State of California  
Department of Water Resources  
Sustainable Groundwater Management Program  
Alternative Assessment Staff Report

Groundwater Basin Name: Ojai Valley (Basin No. 4-002)  
Submitting Agency: Ojai Basin Groundwater Management Agency  
Recommendation: Do Not Approve  
Date Issued: July 17, 2019

Figure 1. Ojai Groundwater Basin<sup>38</sup>

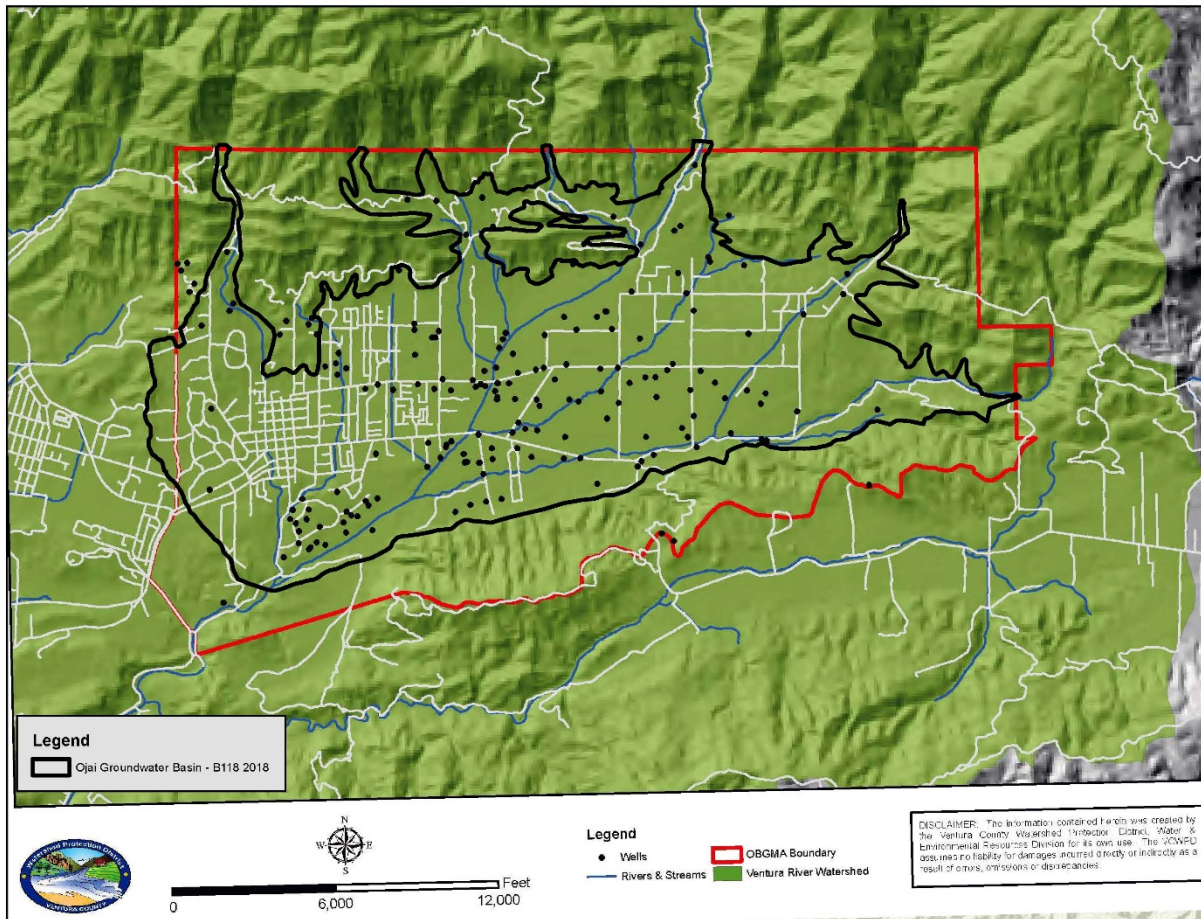
As shown in Figure 1, nearly the entire Ojai Basin (shown in black) is contained within the jurisdictional boundaries of the Ojai Basin Groundwater Management Agency (shown in red), which also includes area beyond the boundaries of the Basin.<sup>37</sup> However, small areas of the Basin extend beyond the Agency's jurisdictional boundary to the north and west.

To determine whether the alternative effectively covers the entire basin, the Department was required to determine whether groundwater management pursuant to the alternative has avoided undesirable results for at least 10 years. Because Department staff has determined that the analysis of basin conditions does not demonstrate that undesirable results have been absent for at least 10 years, the Department staff are unable to determine the Ojai Basin has reached sustainability. As a result, Department staff cannot conclude that the Alternative effectively covers the entire Basin. Although the failure to cover the entire basin precludes an alternative from approval, Department staff note that the failure to cover the entire basin is a consequence of the alternative not demonstrating sustainability in the area within the Agency’s jurisdiction. Department staff do not express

an opinion as to whether the area managed by the Agency would be sufficient to effectively manage the entire Ojai Basin if sustainable groundwater management had been demonstrated.
